MECATOS BAKERY & CAFE

5645 HANSEL AVE
EDGEWOOD, FL 32809

CONSTRUCTION DOCUMENTS

#	Category	Summary	Comments	Responsibility	Response	Status
1	regs.	The landscape plan must follow the current ECO 2021 Amended Ordinance.		LA	Others to Address	
2	Hansel Trees	Per the above referenced ordinance, Division 12 – Edgewood Central District (ECO) Sec. 134-468-Site Design, (h) (2), Highrise live oaks are required 35' on center along Hansel Avenue and Hoffman Avenue. Due to overhead lines on Hansel Avenue, small or understory trees may be used 20' on center. The intent of the trees is to provide shade over the sidewalks. Refer to City current Tree Stock Replacement list for acceptable species.	The trees on Hansel have been changed to meet the ECD requirements.	HCE/Architect	Others to Address	
3	Tree Survey	Provide a tree survey and tree removal and mitigation plan per the requirements of Chapter 130 Tree Management and Protection. Coordinate tree removal with the Civil demolition plans.	Tree survey will be provided. Coordination with the civil demolition plan will also be provided.	Owner	Others to Address

CURB RAMP CR-G DETAIL

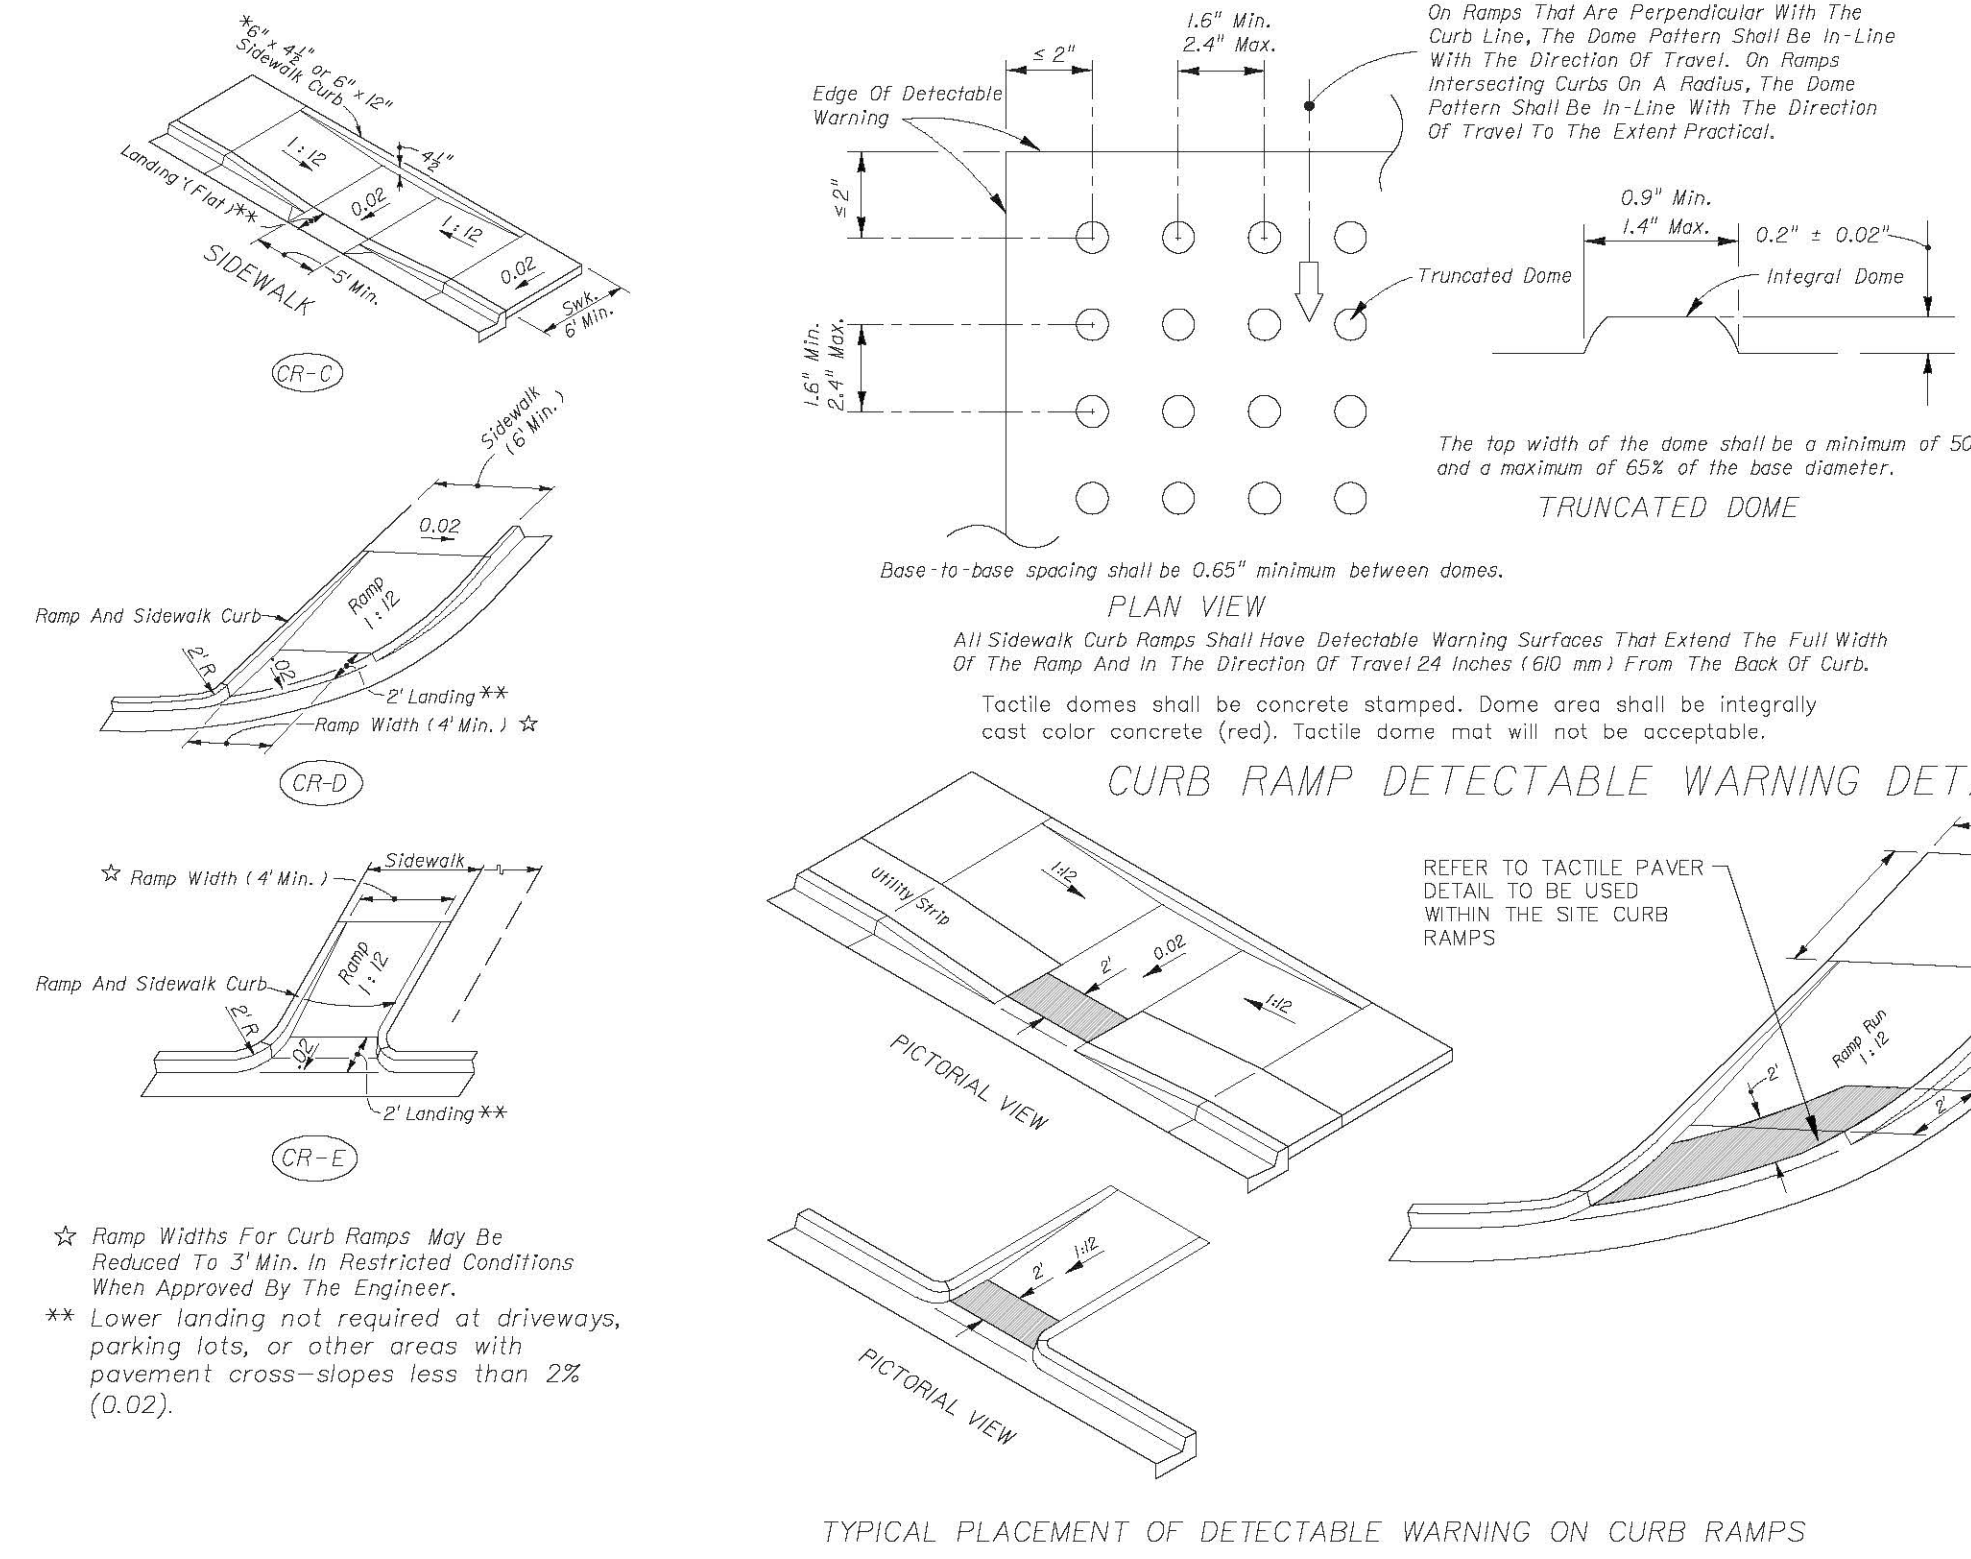
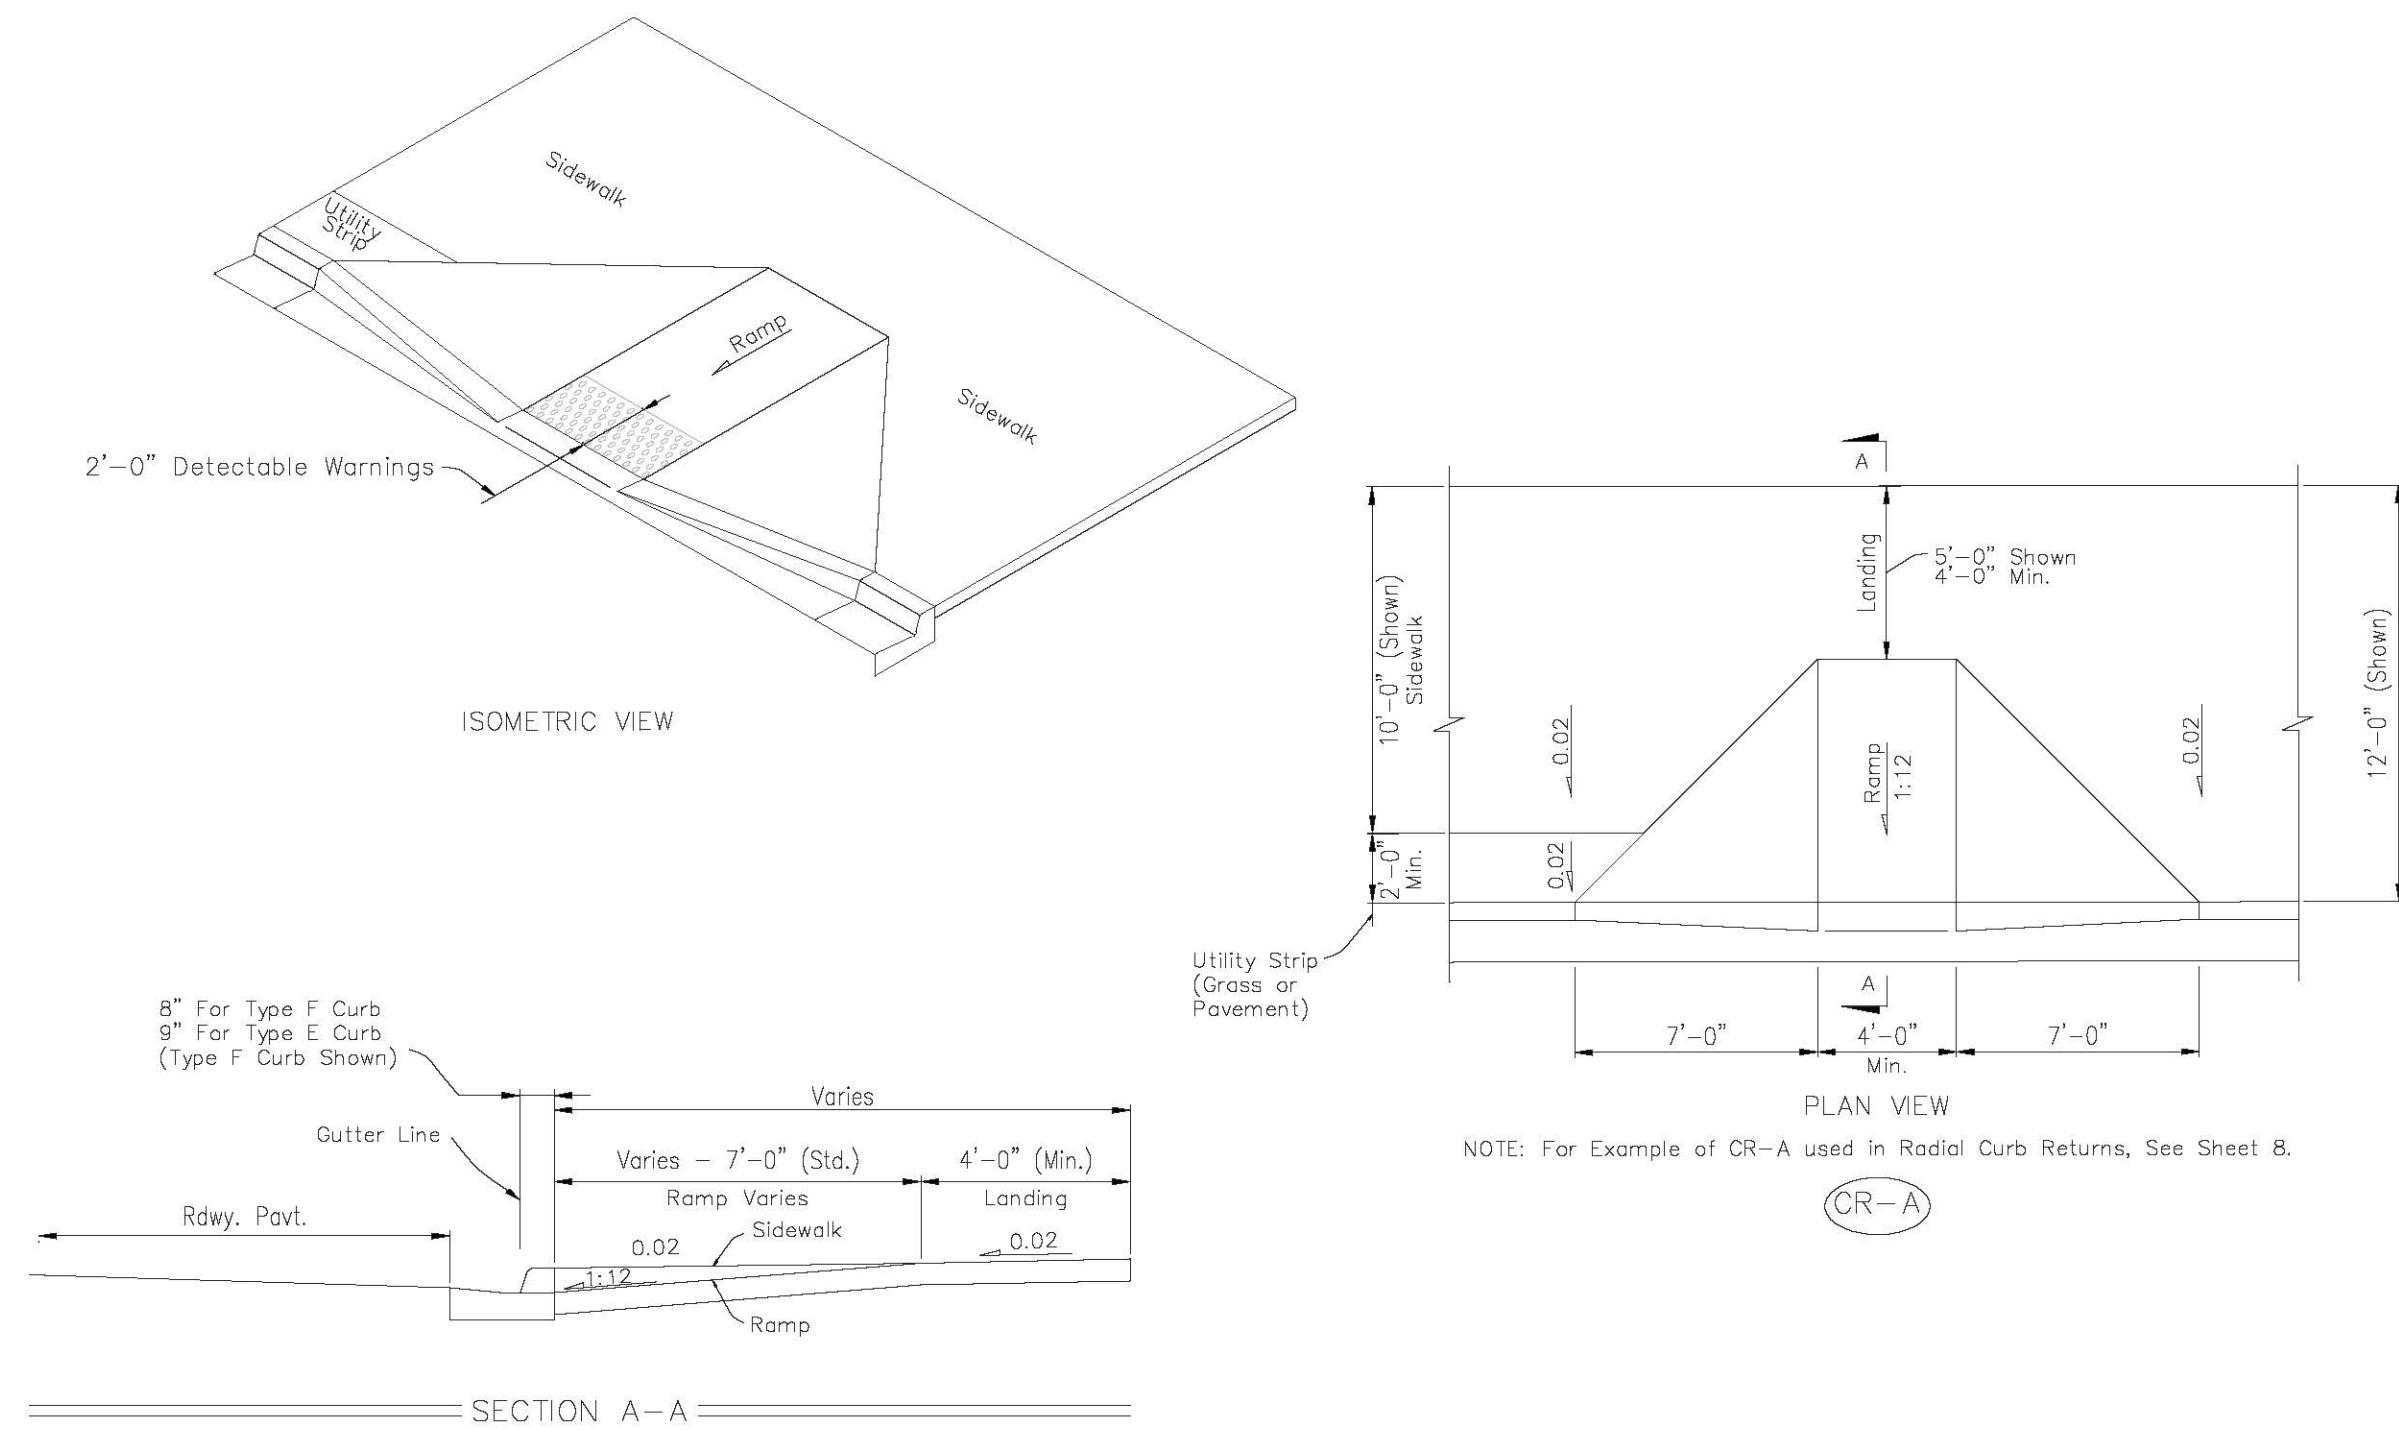
19	ADA Ramp	Call out the appropriate ADA ramp details on site or grading plan from sheet C-401.	The appropriate ADA is called out in C-401	HCE	Sheet C-401, Sheet C-100, ADA ramps called out per Index	
20	Question	What is the purpose of the 20' flush curb SW of the building? How will you protect from vehicular access into seating area?	The flush curb has been removed and replaced with a D curve.	Owner/LA/HCE	Others to Address
